**DEPARTMENT OF TRANSPORTATION
STATE OF GEORGIA
REVISED PROJECT CONCEPT REPORT**

Project Number: NHSTP-0075-03 (203)

P. I. Number: 610870

Changes and reasons for changes:

DRAWING No. 5-04

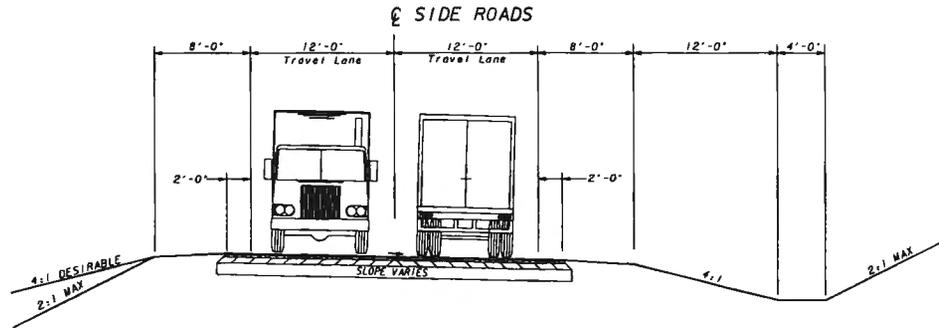
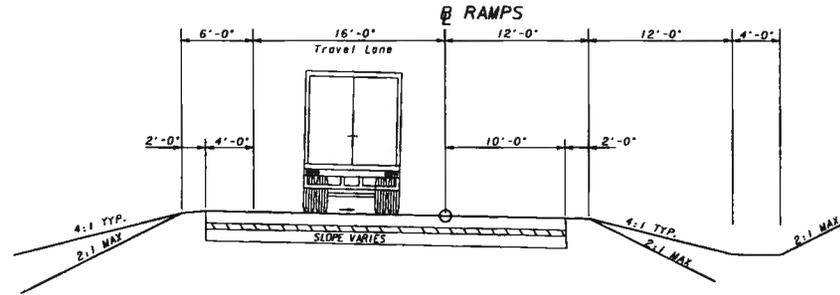
Typical Sections:

The typical section for the ramps is to be revised to provide a 10 ft paved, 12 ft total outside shoulder. GDOT typical paved shoulder widths are 10 ft paved outside shoulders and 4 foot paved inside shoulders on interchange ramps. AASHTO requires a total of 12 ft of paved shoulders on interchange ramps. FHWA agrees that 10 ft paved outside shoulders and 4 ft paved inside shoulders on these interchange ramps are appropriate.

The typical section for the side roads is to be revised to provide a 2 ft paved, 8 ft total outside shoulder. GDOT policy requires 8 ft shoulders with 2 ft paved shoulders for two lane rural local road sections.
